2025 California Building Code Proposed Amendments

Proposed Changes Grouped

FIGURE 11B.809.10.6.3
TRANSFER TYPE SHOWER CLEAR FLOOR SPACE

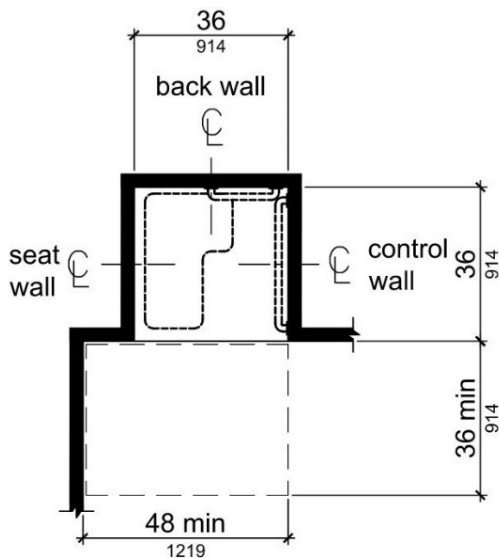
11B-809.10.6.3 Floor space. *A clear maneuvering floor space ~~30 inches (762 mm)~~ 36 inches (914 mm) wide minimum by 48 inches (1219 mm) long ~~minimum in length~~ shall be provided located outside the shower, with the width aligned flush with the control wall and the length measured parallel to the length opening of the shower, as illustrated in Figure 11B-809.10.6.3.*

DSA proposes to amend Section 11B-809.10.6.3 to increase the clear floor space width from 30 inches to 36 inches at showers in residential dwelling units with adaptable features. In the 2022 Intervening Rulemaking Cycle, DSA attempted to clarify in Section 11B-809.10.6.1 the reference to Section 11B-608.1, which specifies the size for transfer showers. In addition to the size, the reference provided for a 36" x 48" clear floor space at the shower fixture, and a subsequent reference in Section 11B-809.10.6.3 which specifies a 30" x 48" floor space, provided for conflicting requirements. While the 30" minimum clear floor space width is the minimum permitted by the Fair Housing Act, individuals with disabilities acknowledged the minimum clear floor space requirements were insufficient. The Building Standards Commission did not approve the proposal and requested that DSA provide further study. DSA advances this proposal to increase to 36" wide the clear floor space at all showers in residential dwelling units with adaptable features. A figure is necessary to illustrate the position of the clear floor space relative to the control wall of the shower. (See companion proposal for Section 11B-809.10.6.1.)

11B-809.10.6.3 Floor space. A clear floor space 36 inches (914 mm) wide minimum by 48 inches (1219 mm) long minimum shall be provided, with the width aligned with the control wall and the length measured parallel to the opening of the shower, as illustrated in Figure 11B-809.10.6.3.
